HISTORIC AND DESIGN REVIEW COMMISSION

April 19, 2023

HDRC CASE NO: 2023-099
ADDRESS: 327 E KINGS HWY
LEGAL DESCRIPTION: NCB 6327 BLK 2 LOT 50
ZONING: R-5, H
CITY COUNCIL DIST.: 1
DISTRICT: Monte Vista Historic District
APPLICANT: Oscar Flores/Oscar Flores Design Studio
OWNER: JOHN MALONEY/MALONEY JOHN PATRICK JR
TYPE OF WORK: New construction of a 2-story, single-family structure and a 1-story detached garage
APPLICATION RECEIVED: March 10, 2023
60-DAY REVIEW: Not applicable due to City Council Emergency Orders
CASE MANAGER: Rachel Rettaliata

The applicant is requesting conceptual approval to construct one 2-story, single-family structure and one 1-story detached garage at 327 E Kings Hwy.

29' X 0.1% = 31.9' ALLOWED
HEIGHT BASED ON TALLEST
ADJACENT RESIDENT ONLY
STRUCTURES

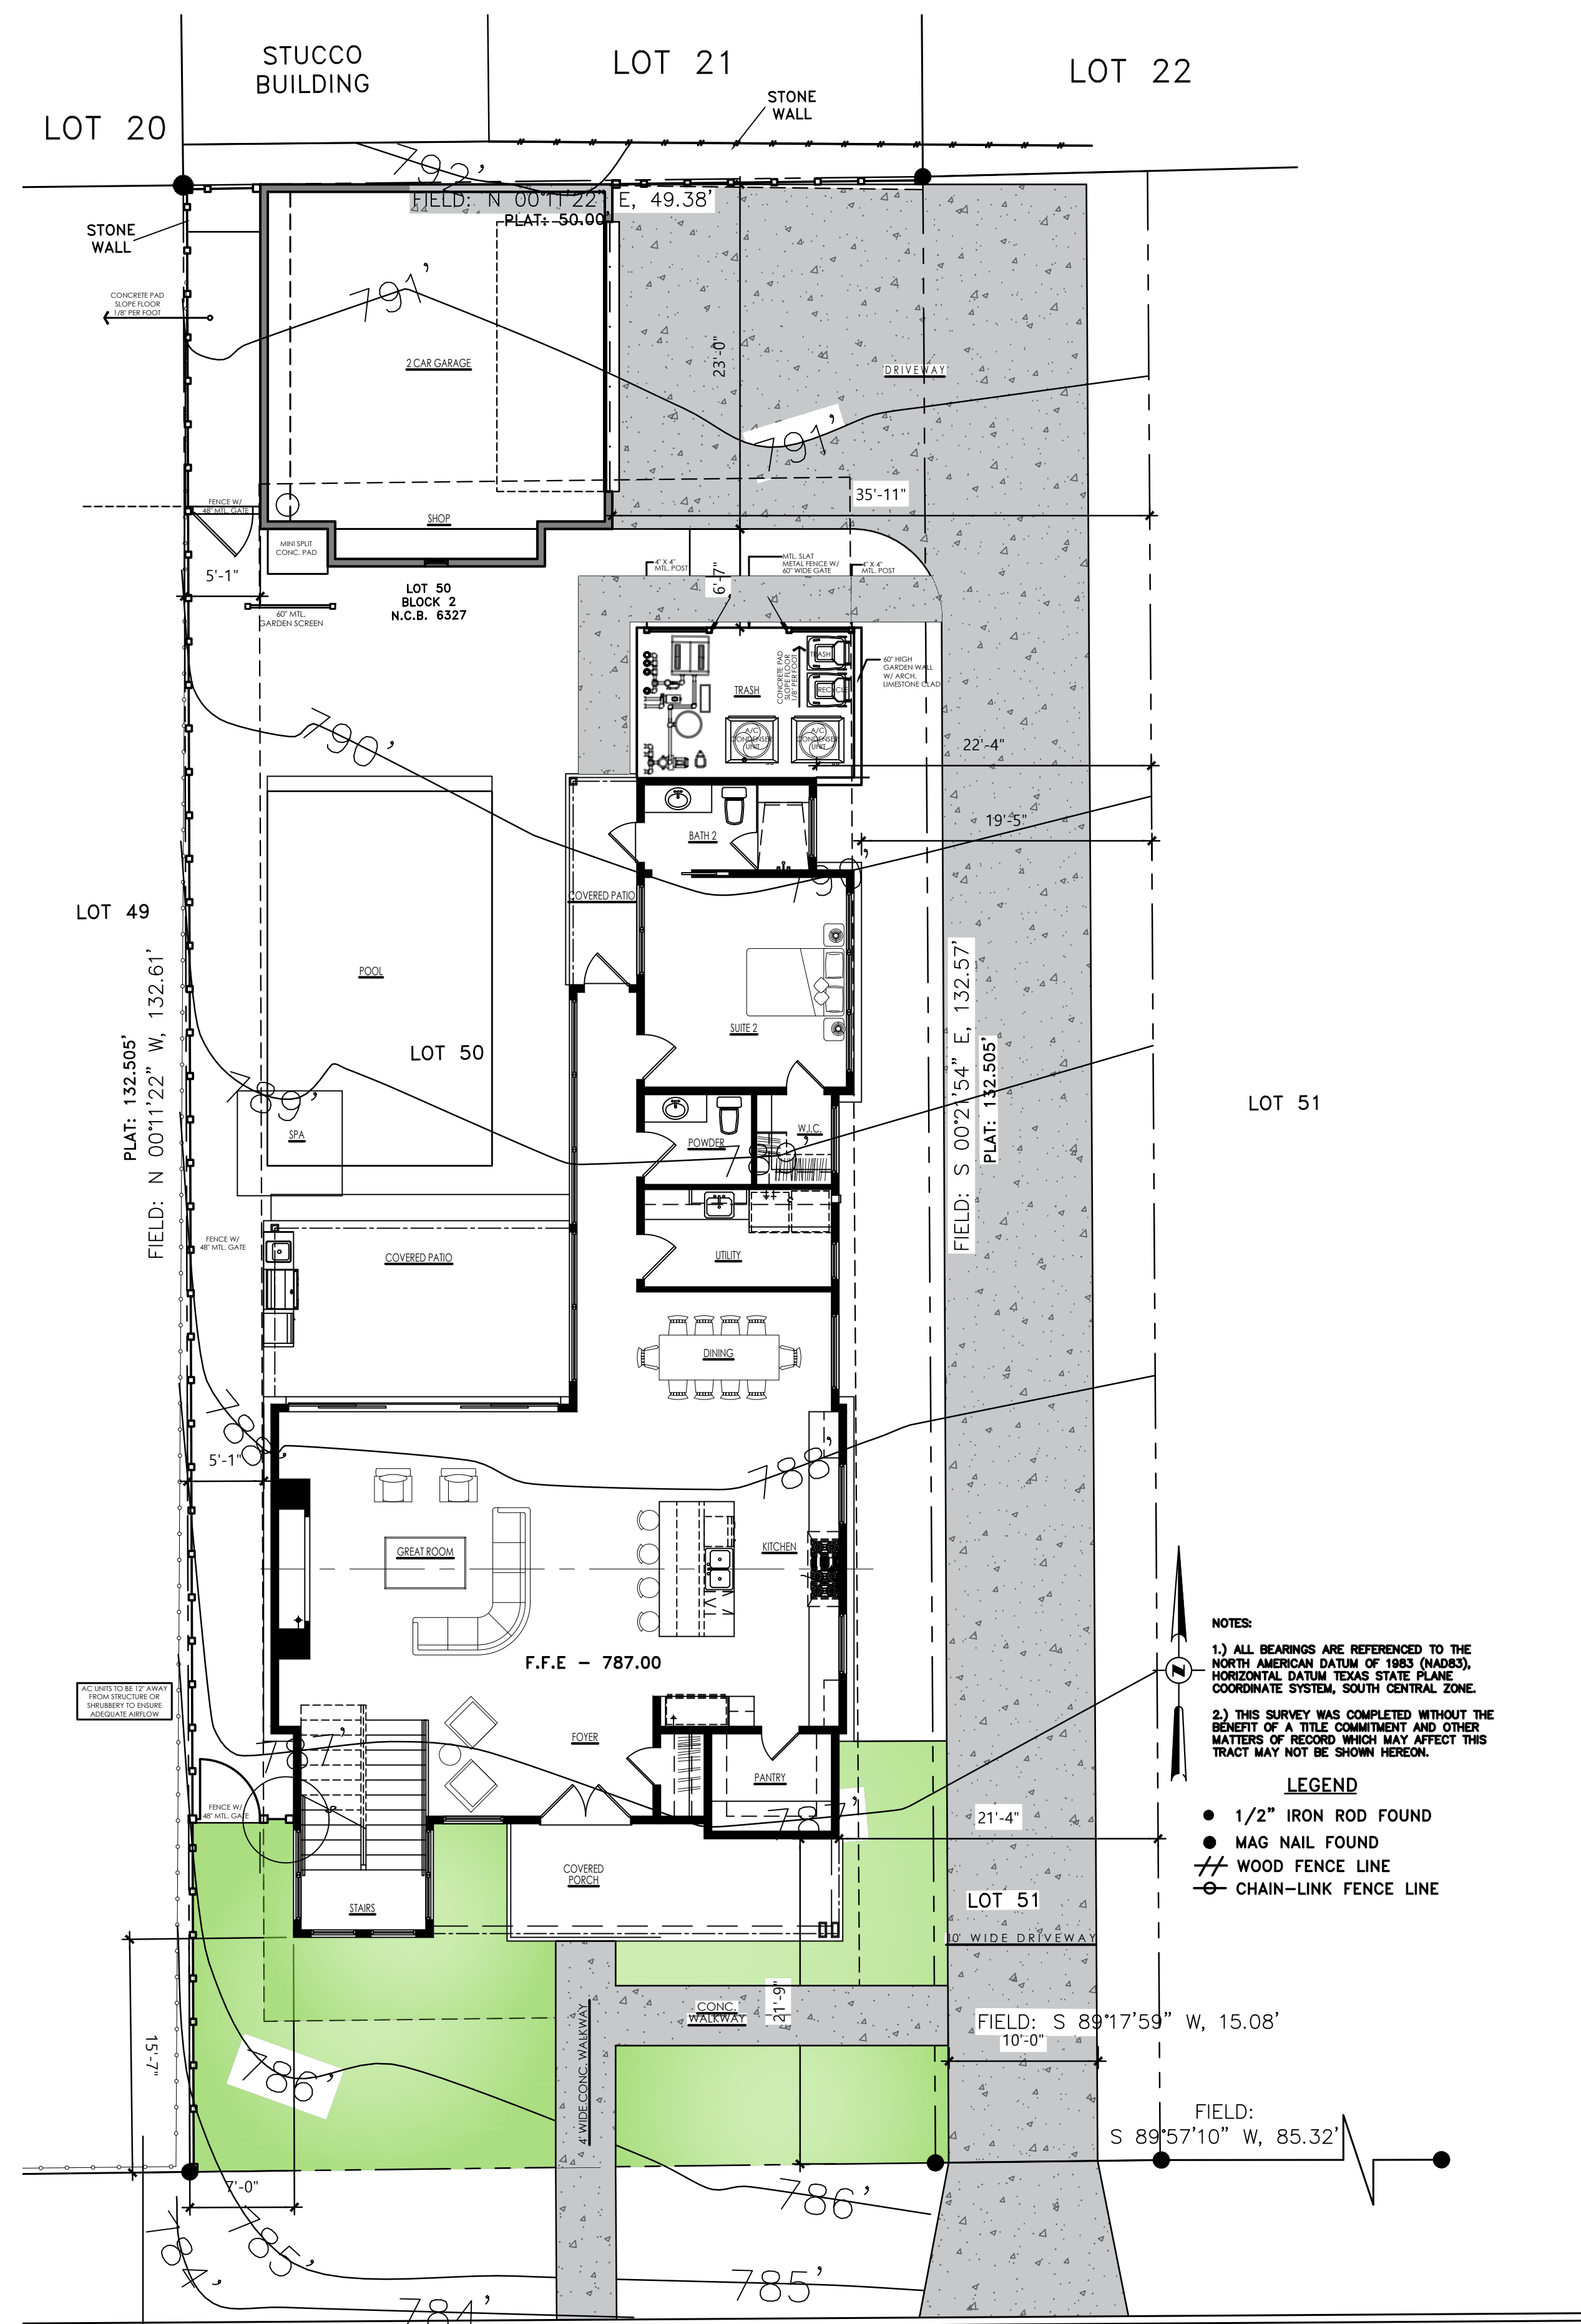
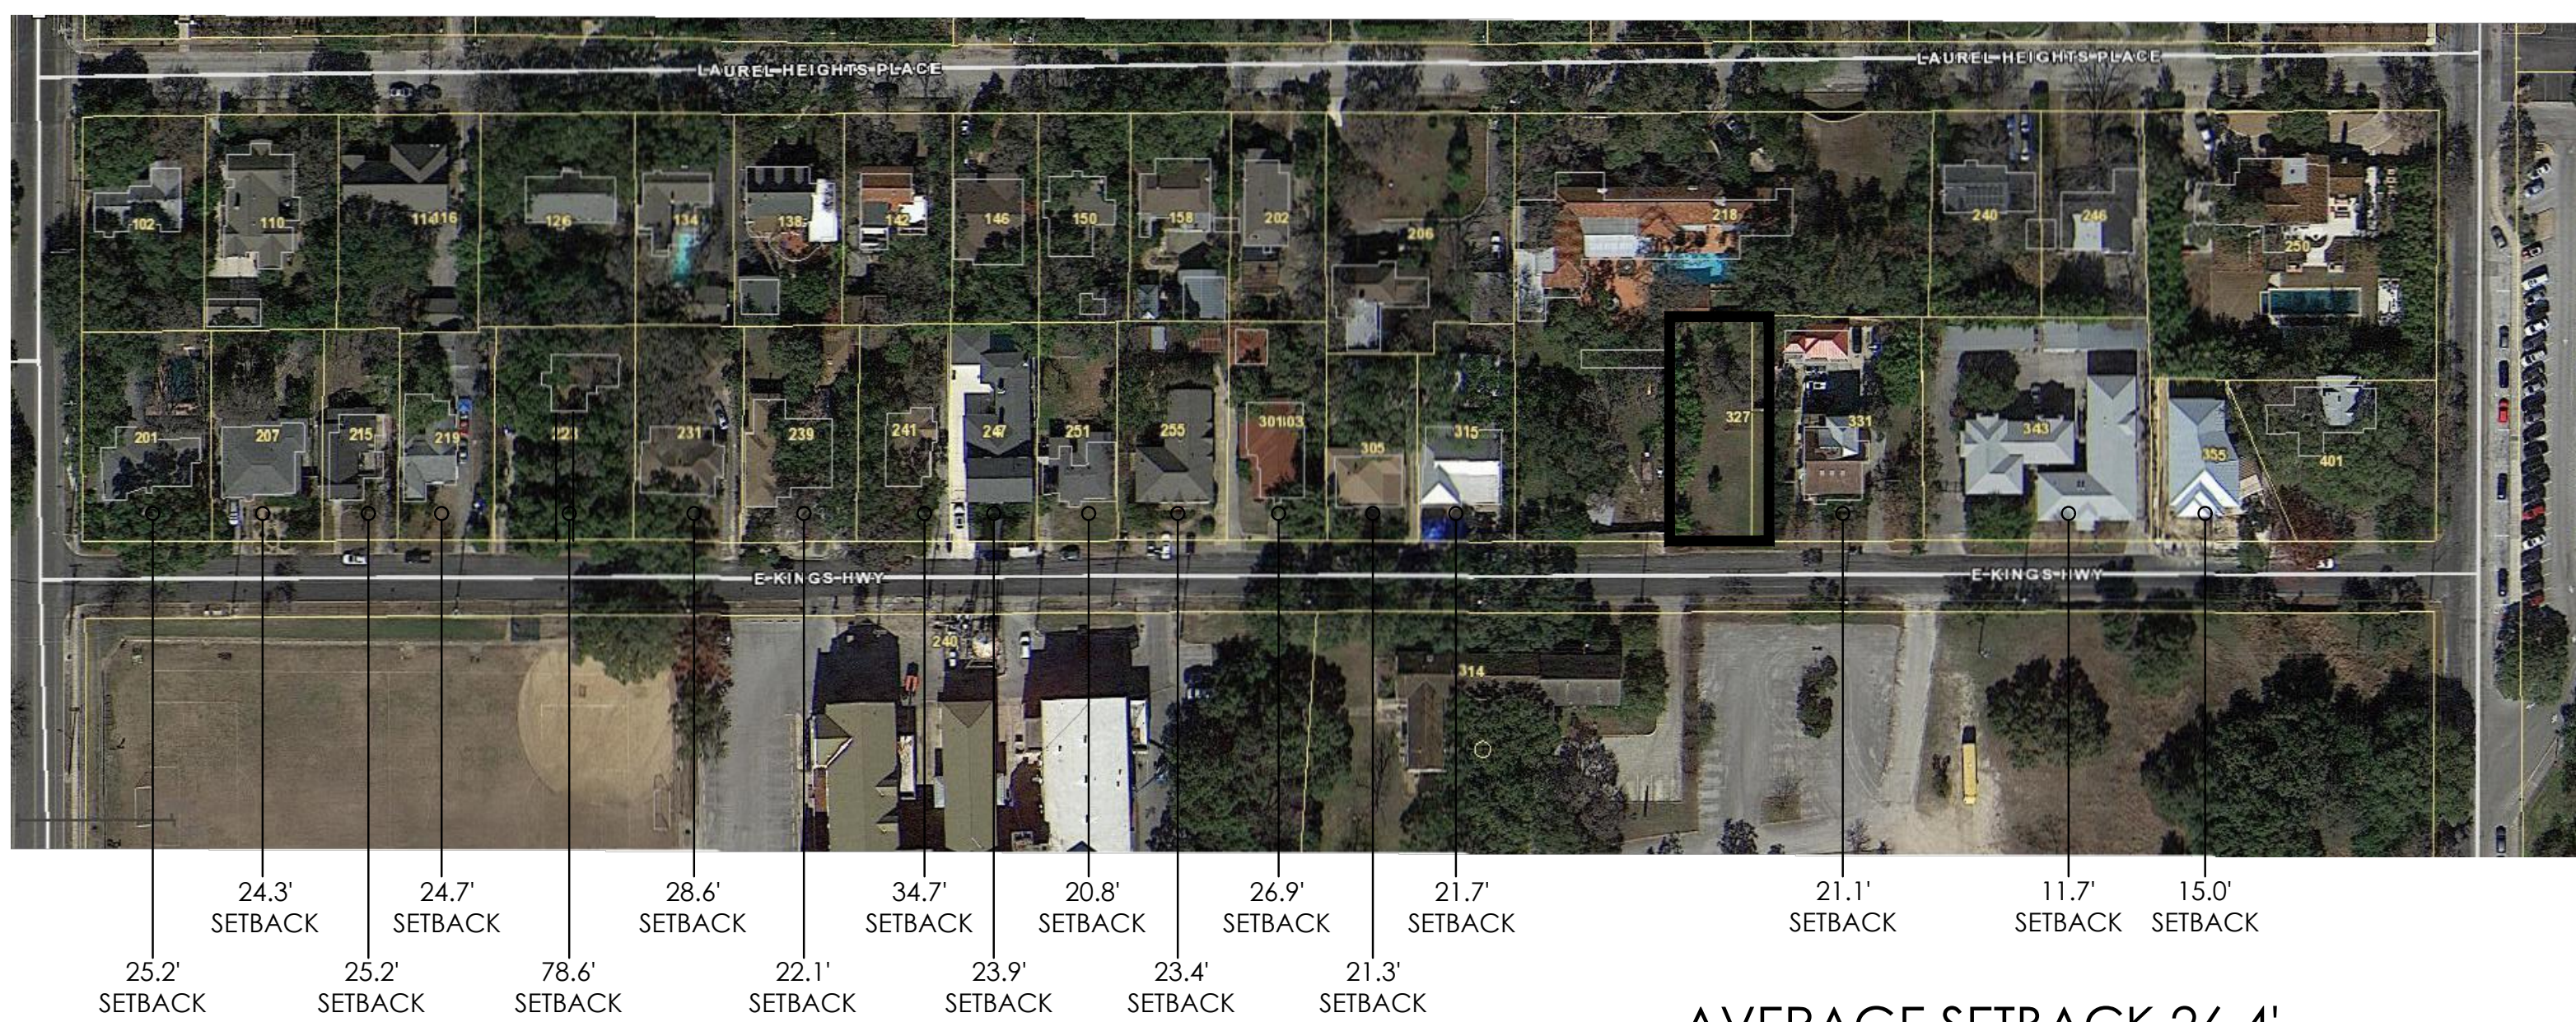
- f. **SCALE & MASSING** – According to Guideline 2.A.i for New Construction, new structures should feature a height and massing that is similar to historic structures in the vicinity. In residential districts, the height and scale of new construction should not exceed that of the majority of historic buildings by more than one story. This immediate block of E Kings Hwy features 1- and 2-story single family and multifamily residences. Additionally, the property is located across the street from San Antonio Academy and Lang Field. The proposed new construction will total 29’-4 ½” at the ridge height. The applicant has provided a study showing that, based on other residential structures in the district, a ridge height of up to approximately 32’ is appropriate. Staff finds that the applicant should provide a height study that includes the neighboring 2-story structure for review.

1 SITE PLAN
SCALE:1/8"=1'-0"

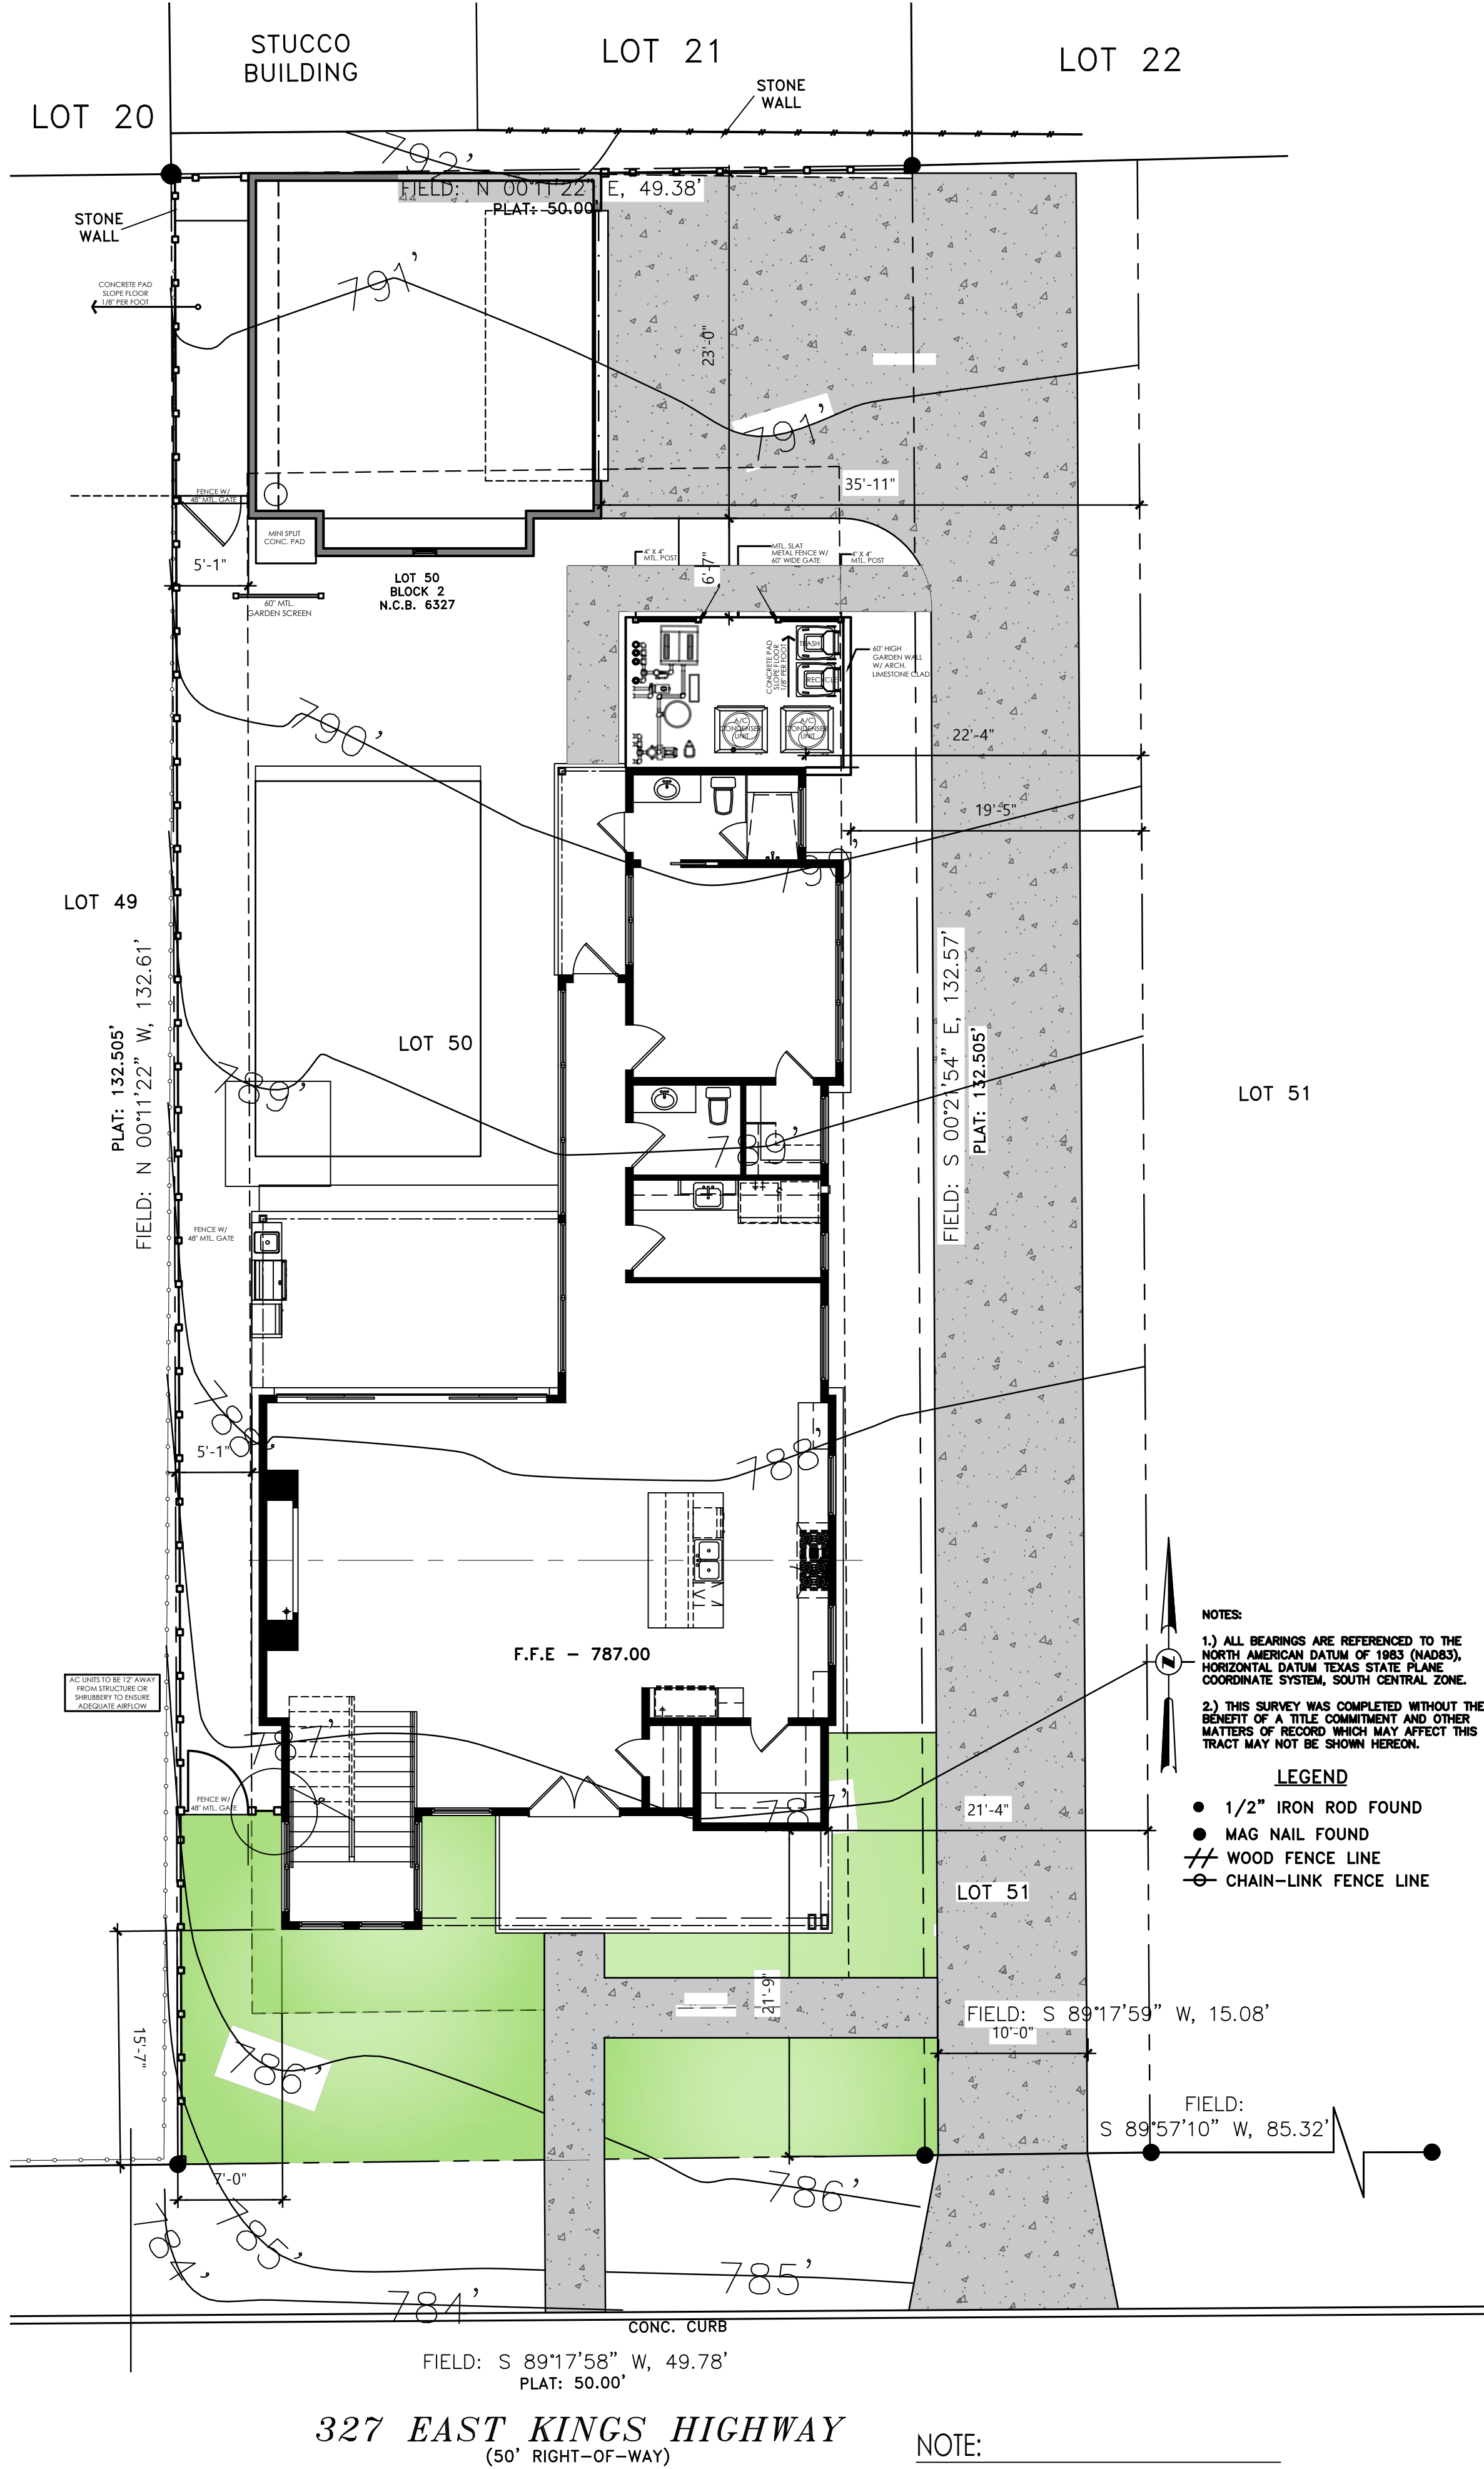
- d. **SETBACK & ORIENTATION** – According to the Guidelines for New Construction, the front facades of new buildings should align with the front facades of adjacent buildings where a consistent setback has been established along the street frontage. Additionally, the orientation of new construction should be consistent with the historic examples found on the block. The applicant has proposed to construct one 2-story, single-family residence at 327 E Kings Hwy. The residence will be oriented toward E Kings Hwy. The applicant has noted that the proposed setback from E Kings Hwy will be 15’-7”. The Historic Design Guidelines for New Construction stipulate that primary building entrances should be oriented towards the primary street and that front facades should be aligned with the front facades of adjacent buildings. The applicant has provided a setback diagram showing that the setbacks of adjacent structures are over 21 feet. Staff finds that the applicant should propose a setback that is consistent with historic examples found on the block.
